# Access Compliance Report

## Public Rights-of-Way (Curb Ramps)

Intersection ID: 11208	Main Street: PARKWOOD_AV	Cross Street: N_BREVARD_ST	Location: SW
ADA ID: 870333C840F5	Ramp Type: Para	Initial Pass/Fail: Pass	Overall Compliance: No Severity Score: 5

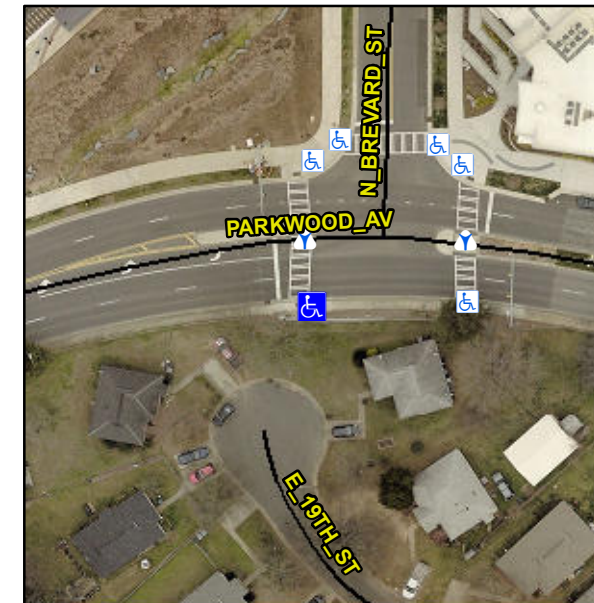
### Codes/Mitigation Info/Possible Solution

**R304.5.4**

**Remove & Replace Gutter.**
